## 4.8 HD Fleet Master Gearcase on Mercury Racing Outboards

Models Covered	Serial Number Range
OptiMax—DSI, 300XS, 250XS with Fleet Master Gearcase	1E053093 and above
OptiMax—300XS, 250XS, JP5 with Fleet Master Gearcase	1E053092 and below

62949

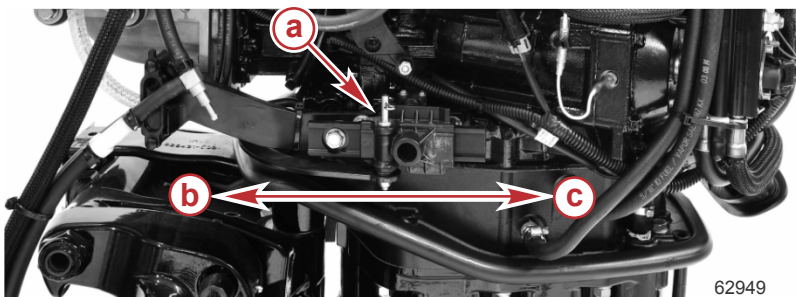
When installing a counterrotation 4.8 HD Fleet Master gearcase on a DSI, 300XS, or 250XS, the shift cable at the remote control must be installed so the shift slide on the engine moves forward when the remote control is shifted into forward gear. Standard rotation 4.8 HD Fleet Master gearcase installation does not require changing the position of the shift cable at the remote control.

- a** - Shift slide
- b** - Counter and standard rotation—forward gear
- c** - Counter and standard rotation—reverse gear
